RESUBDIVISION PLAT ESTABLISHING
AFTON OAKS SUBDIVISION UNIT 1A

**PRELIMINARY OVERALL
AREA DEVELOPMENT PLAN
AFTON OAKS**

Re: Afton Oaks ☐ Preliminary Plan
File #: 84-16-64-44 ☒ P.O.A.D.P.

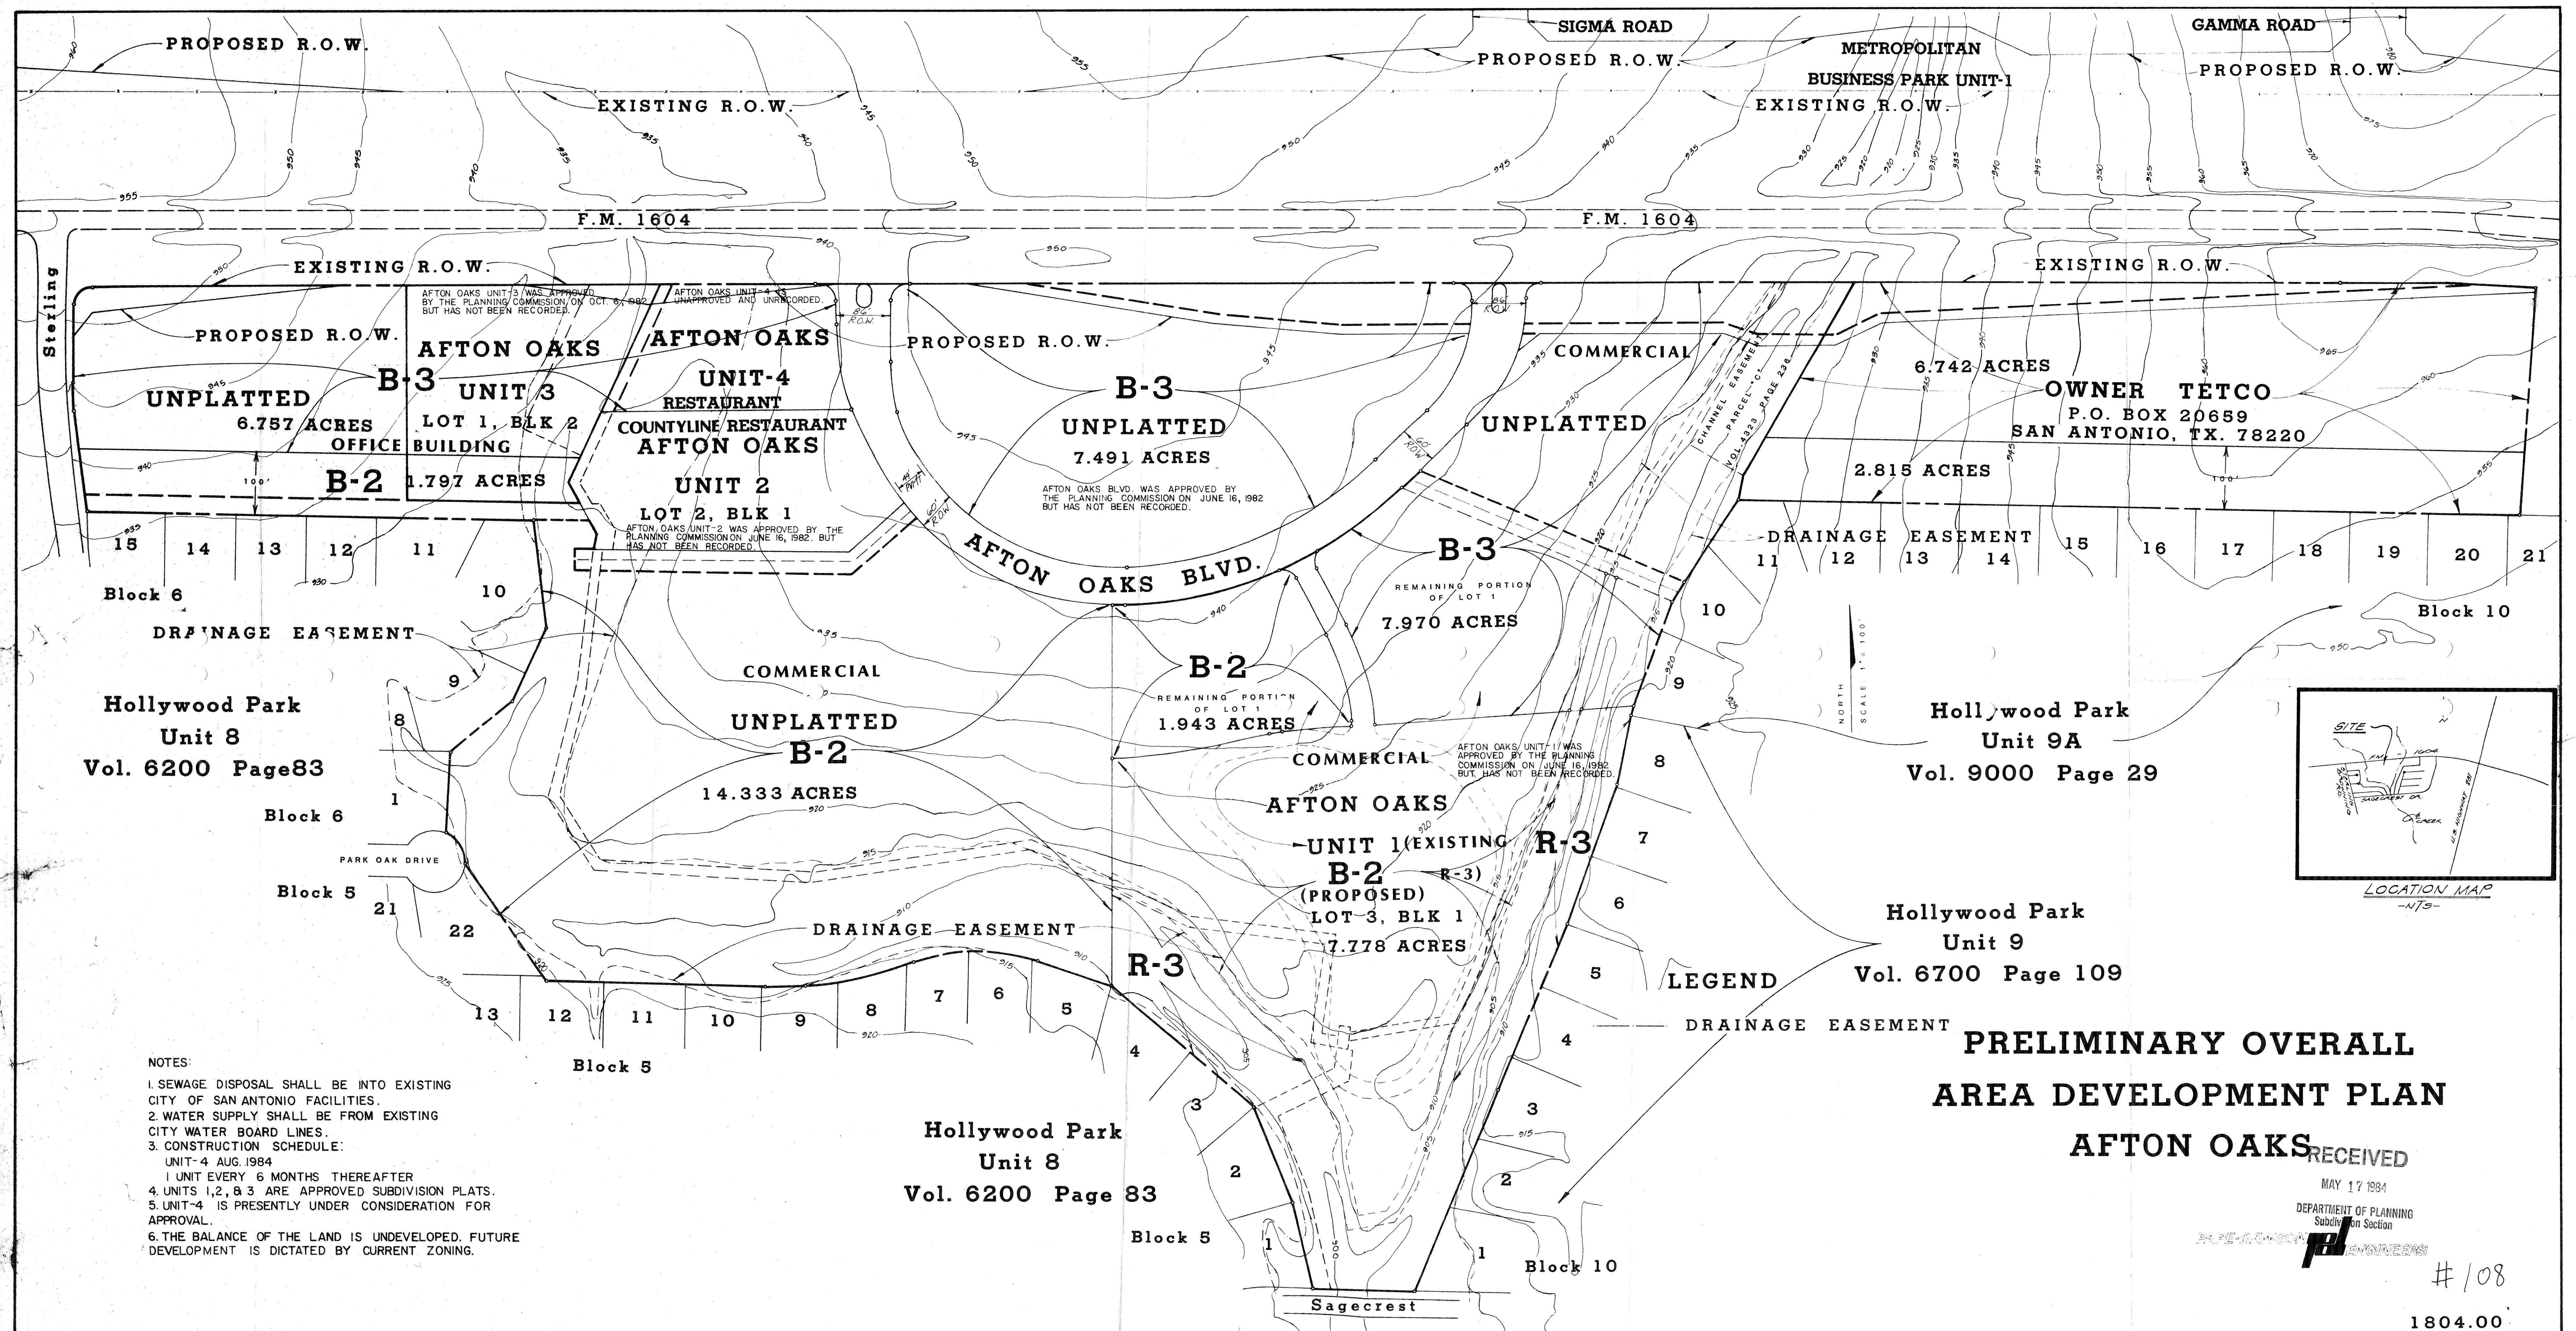
- ☒ (a) perimeter property lines; clarify boundary limits
- ☒ (b) name of the plan and the subdivisions; give update info per sea draft app & record
- ☒ (c) scale;

- ☒ (d) proposed land use(s) by location on map;
- ☒ (e) existing and proposed circulation system of collector and arterial streets and their relationship to any adjacent major thoroughfares and any proposed alternative transportation circulation system (bikeways, lanes, paths, etc.);

- ☒ (f) the proposed source and type of sewage disposal and water supply;
- ☒ (g) contour lines at no greater than ten (10) foot intervals;
- ☒ (h) projected sequence of phasing; define limits of each phase

- ☒ (i) existing and/or proposed zoning classification(s);
- ☒ (j) known ownership and proposed development of adjacent undeveloped land; and
- ☒ (k) existing adjacent streets or development which impact upon process decisions within the proposed FOADP.

revised FOADP as requested 5.17.84
